ADDRESS . . : 126 CAROLINA OAKS CIR  
 CONTRACTOR : ELK RIDGE AT SOUTHVIEW LLC  
 OWNER . . : RAM DEVELOPMENT INC  
 PARCEL . . : 01-0544- - -0012- -06-  
 APPL NUMBER: 07-50018463 CP NEW RESIDENTIAL (SFD)  
 DIRECTIONS : SOUTH 401 TO ELLIOTT BRIDGE RD TO WILL  
 LUCUS RD S/D ON RIGHT LOT 6 JB

**PERMIT: CPSF 00 CP \* SFD**

**COUNTY OF HARNETT  
DEPARTMENT OF BUILDING INSPECTION  
AND PLANNING/DEVELOPMENT  
CERTIFICATE OF OCCUPANCY**

Job #74863	Truss F01	Truss Type FLOOR	Qty 10	Qty 1	Rem Descr. - Lot 6 Carolina Oaks	4980387
Comtech Inc., Fayetteville, NC 28308					Job Reference (optional)	
7.050 s May 22 2008 MITek Industries, Inc. Mon Jun 09 10:00:55 2008 Page 1

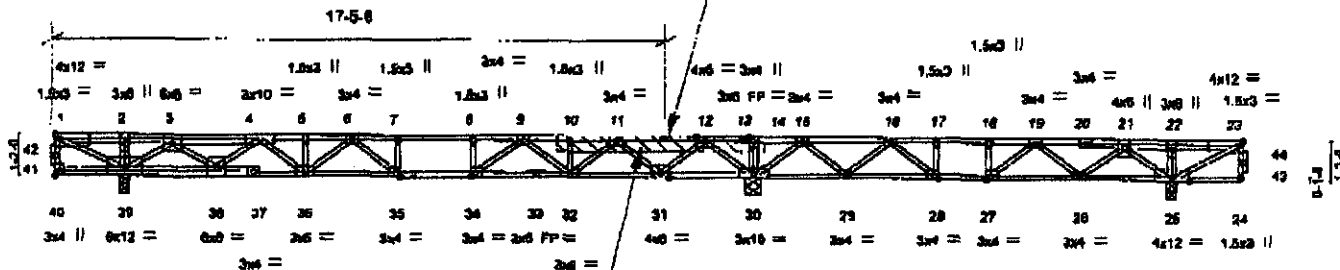
2" WIDE X 3/8" DEEP DAMAGED SECTION

APPLY 2X6 X 5'-0" SPF NO.2 SCAB TO ONE SIDE OF TRUSS, CENTERED ON DAMAGE, WITH CONSTRUCTION QUALITY ADHESIVE AND 1 ROW OF 10d (3" X 0.131") NAILS SPACED 3.0' O.C.
